**SUBDIVISION,  
PLANNED UNIT DEVELOPMENT, &  
REZONING STAFF REPORT****Date: September 17, 2015**

<b><u>APPLICANT NAME</u></b>	Daniel Clark
<b><u>SUBDIVISION NAME</u></b>	Mack Manufacturing Subdivision, Resubdivision of
<b><u>DEVELOPMENT NAME</u></b>	Mack Manufacturing Subdivision, Resubdivision of
<b><u>LOCATION</u></b>	7205 Bellingrath Road (East side of Bellingrath Road at the East terminus of Will Casher Lane)
<b><u>CITY COUNCIL DISTRICT</u></b>	Council District 4
<b><u>PRESENT ZONING</u></b>	I-2, Heavy Industry District, and R-1, Single-Family Residential District
<b><u>PROPOSED ZONING</u></b>	I-2, Heavy Industry District
<b><u>AREA OF PROPERTY</u></b>	1 Lot/10.9± Acres
<b><u>CONTEMPLATED USE</u></b>	<p>Subdivision Approval to create one legal lot of record from an existing legal lot of record and two existing metes-and-bounds parcels; Planned Unit Development to amend a previously approved Planned Unit Development to allow multiple buildings on a single building site, accommodate existing and future businesses, and reduced front landscaping requirements, and Rezoning from R-1, Single-Family Residential District, to I-2, Heavy Industry District, to accommodate an existing an

# DETAIL SITE PLAN

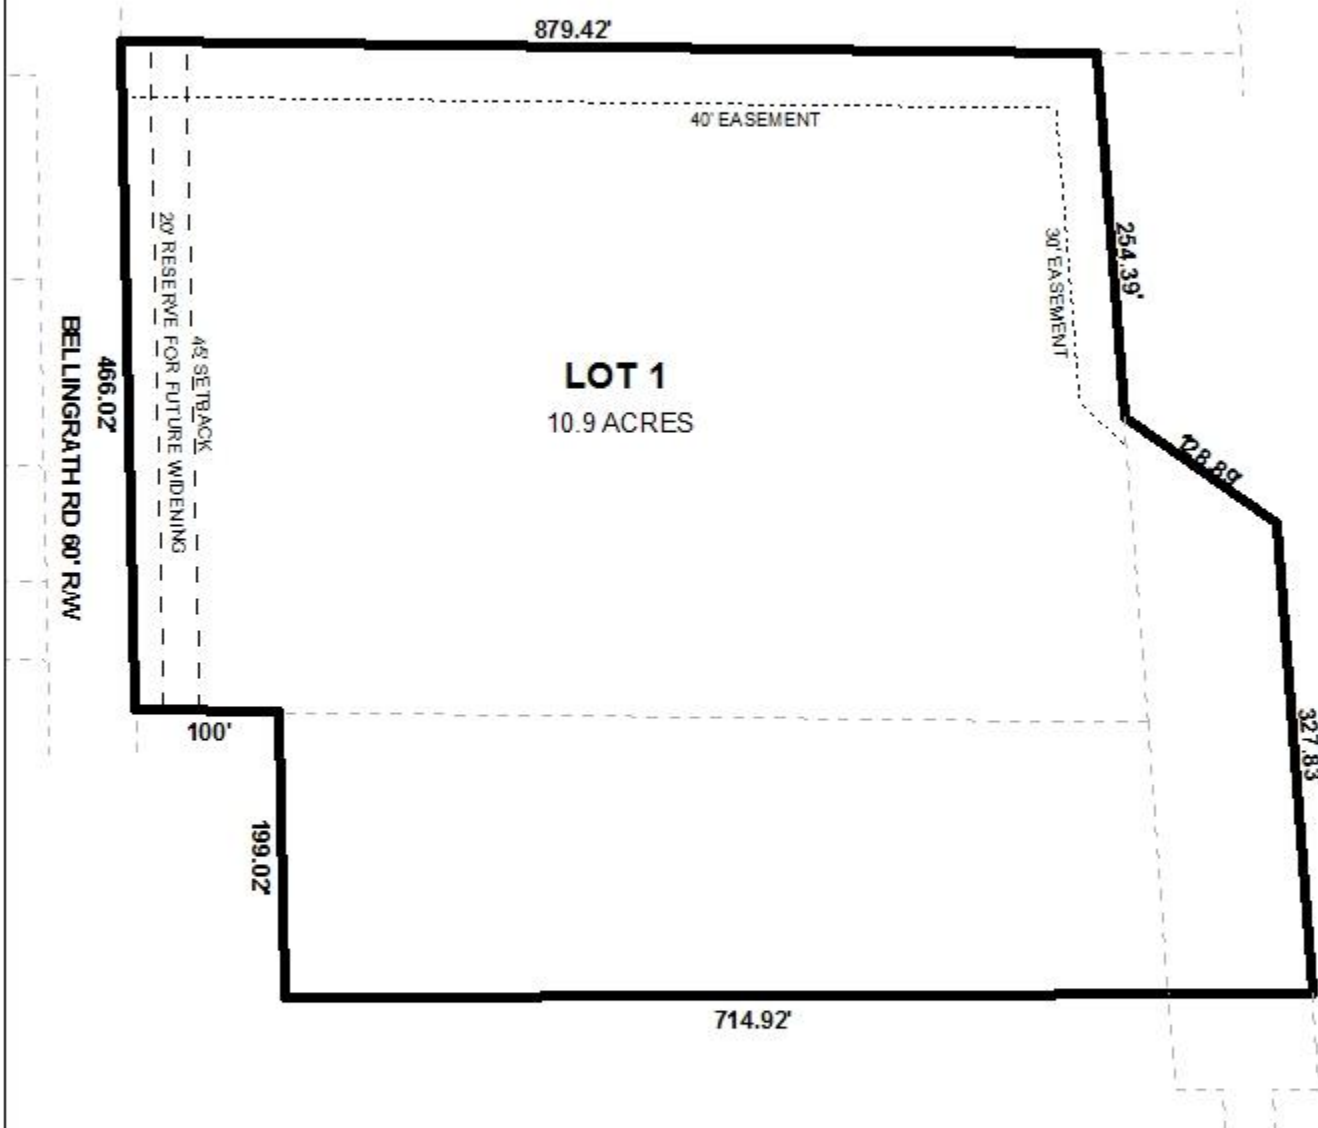
A review of the preliminary Subdivision plat and the site plans for the PUD and Rezoning indicates that one of the two parcels (R023802102000176) proposed to be added to the site is not included in its entirety. Only that portion directly adjacent to the East of the proposed new South line of the site is included. The applicant purchased this portion via a parceling sale without going through the proper Subdivision process. The complete parcel was land-locked and the sale produced a further smaller land-locked parcel not allowed by the Subdivision Regulations. In order to proceed with a detailed review of the applications presented, the entire parcel must either be included in all three applications, or it must be combined as a second lot in the Subdivision with a larger parcel (R023802103000001) to the South also owned by the seller which has access to two public streets (Ann Street and Helen Drive). However, this would require either the de-annexation of the remaining portion of Parcel R023802102000176, or the annexation of the larger parcel to prevent the creation of a lot partially in and partially out of the City limits.

- 1) the remainder of Parcel R023802102000176 was not included in the one-lot Subdivision nor was it combined with Parcel R023802103000001 as a second lot in a two-lot Subdivision.*

- 1) *the remainder of Parcel R023802102000176 was not included in the PUD nor was it combined with Parcel R023802103000001 as a second lot in a two-lot Subdivision.*

- 1) *the remainder of Parcel R023802102000176 was not included in the Rezoning nor was it combined with Parcel R023802103000001 as a second lot in a two-lot Subdivision.*
